# **SHIRE OF DENMARK**

### **AMENDMENT No. 149**

**PROPOSAL TO AMEND A TOWN PLANNING SCHEME**

*To move portion Lot 9010 Beaufortia Gardens, Hay, Shire of Denmark, from the Tourist (T9) zone and Parks and Recreation reserve to the Special Residential (SRes6) zone, to rezone Lots 193, 194, 195 & 196 Pimelea View & portion Lots 180, 181, 182 & 184 Beaufortia Gardens from the Tourist (T9) zone to the Special Residential (SRes6) zone, to move a portion of Reserve 52123 from the Tourist (T9) zone to the Parks and Recreation reserve and to delete Tourist Zone (T9) from Appendix XIII of the Scheme.*

**Figure 1. Revised road design proposal  
(proposed revised road shown in yellow highlight)**

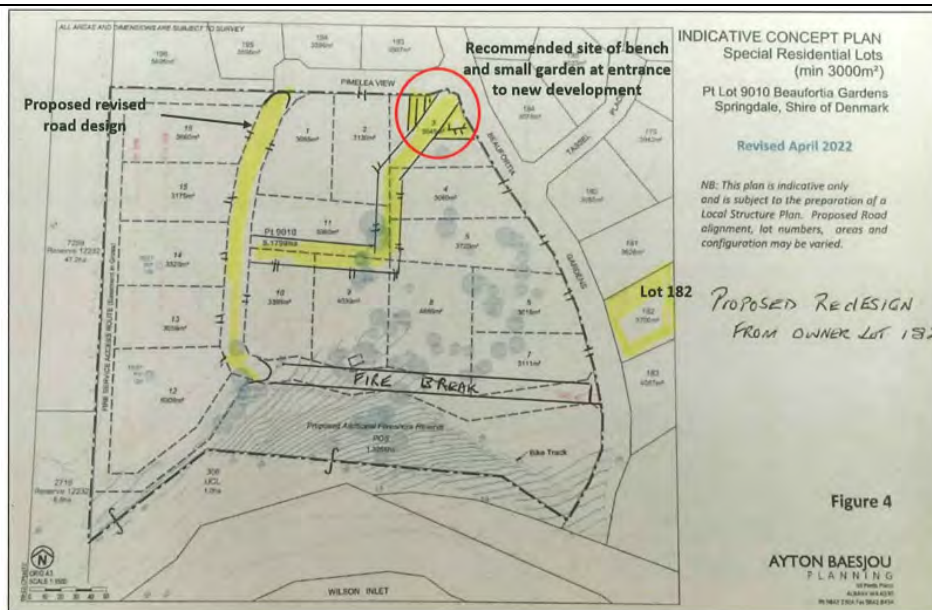
<p>an 8% incline and limited visibility.</p> <p>d. Safety for vehicles approaching a currently blind intersection from the Springdale Beach car park.</p> <p>e. Numerous driveways (seven) exiting onto Beaufortia Gardens, immediately above the planned intersection site, further increasing the risk to traffic emerging from the loop road onto Beaufortia Gardens on an 8% incline.</p> <p><b>Recommendation: Revised Road Design Proposal</b></p> <p>An attached proposal for a redesign of road access into the proposed development brings traffic into the development itself from the Pimelia View – Beaufortia Gardens intersection (see Figure 1). The current block designs could be adjusted with only a small reduction to 16 lots. Where the proposed revised access road enter Beaufortia Gardens, tree planning could cover the view of the exposed cleared blocks. A bench and a little garden at this site would assist cyclists and pedestrians utilizing the current bike/ pedestrian path. This would provide both an entrance statement for this new development area and a scenic lookout.</p>

The primary benefits of this revised proposal are listed below:

Figure 7

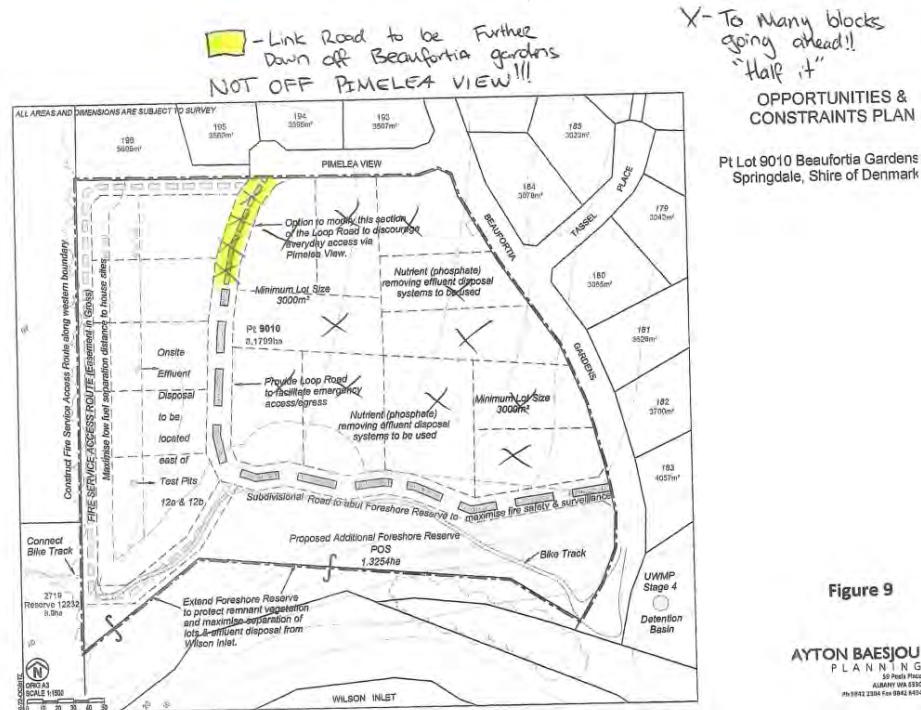
**The primary benefits of this revised proposal are listed below:**

1. Decreased environmental damage to the Springdale Beach Reserve.
2. Reduction of otherwise significant noise street lighting and car headlight impacts for blocks 181, 182 & 183.
3. General reduction of traffic-related noise issues for Beaufortia Gardens.
4. Improved safety for vehicles exiting driveways onto Beaufortia Gardens
5. Improved safety for expected traffic utilizing the car park at Springdale Beach
6. Improved safety for cyclists and pedestrians utilizing the current path.
7. An opportunity for LWP to enhance the magnificent view from the high point of Beaufortia Gardens
8. Contribution to a community feel within the new development, with access
